SUBJECT: ISSUANCE OF AMENDMENT FOR THE PALO VERDE NUCLEAR GENERATING STATION UNIT NO. 1 (TAC NO. M82343)

Amendment No. 61
License No. NPF-41

AMENDMENT NO. 61 TO FACILITY OPERATING LICENSE NO. NPF-41

RELATED TO AMENDMENT NO. 61 TO FACILITY OPERATING LICENSE NO. NPF-41

FIGURE 3.2-2

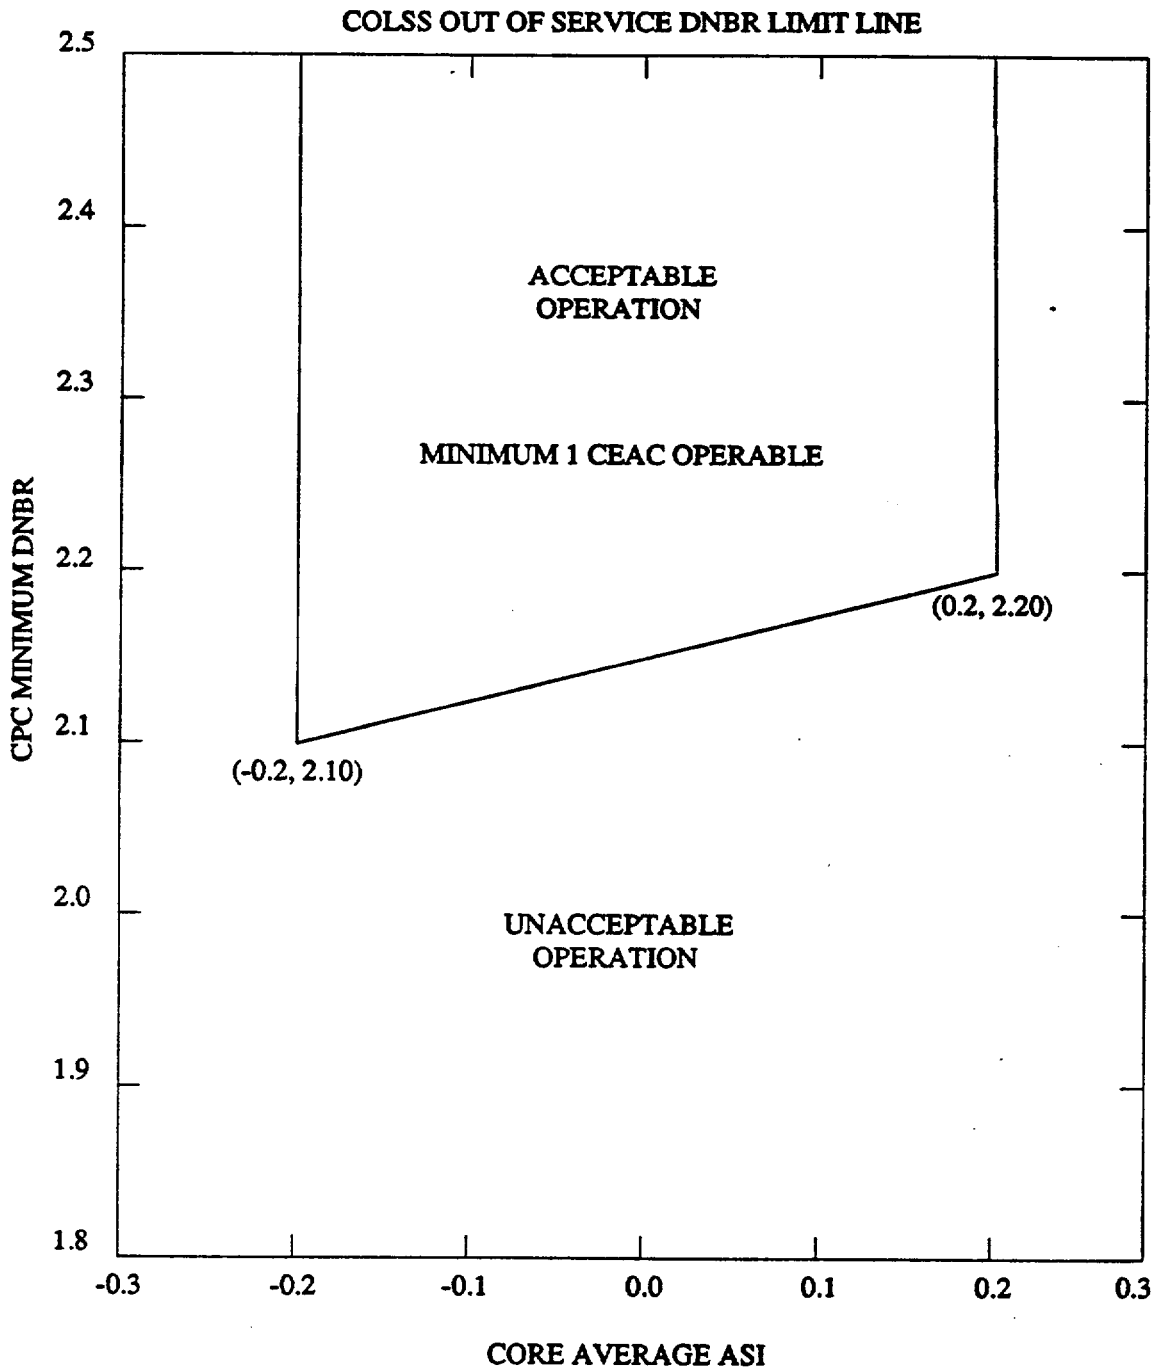
8.1 TS Figures 3.2-2 and 3.2-2A

Figure 3.2-2 provides DNBR margin limits when at least one control element assembly calculator (CEAC) is operable and the core operating limit supervisory system (COLSS) is out of service. Figure 3.2-2A provides the additional DNBR margin necessary when COLSS and both CEACs are out of service. Reactor operation within these limits ensures that the specified acceptable fuel design limits (SAFDLs) will not be violated during an anticipated operational occurrence.

The proposed changes are necessary to ensure consistency of the TS with the safety analyses performed for cycle 4, and are therefore acceptable.
